Cree® XLamp® XB-D Color LED Product Change Notification

PCN Reference Number: CREE-PCN-1063

Date Issued: April 14, 2020

XB-D

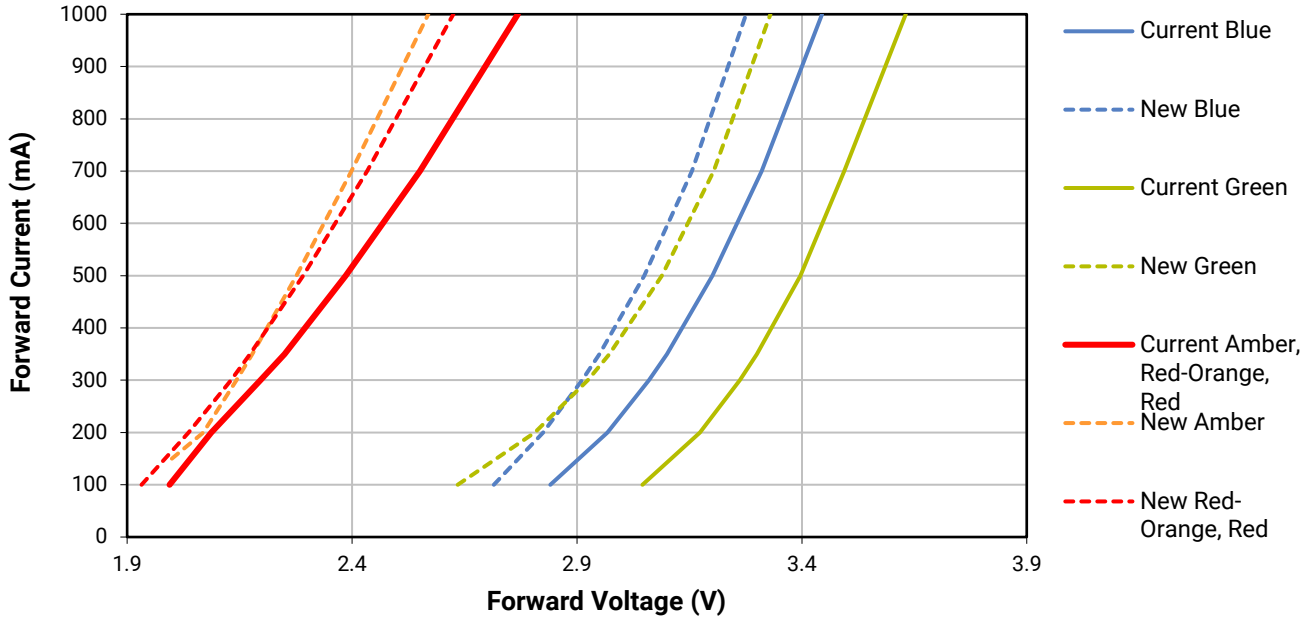
Cree will be changing the typical forward voltage, temperature coefficient of voltage, and thermal resistance characteristics for XB-D color LEDs. Table 2 shows the current and new values.

The following graph shows the improved Forward Voltage vs. Current curves.
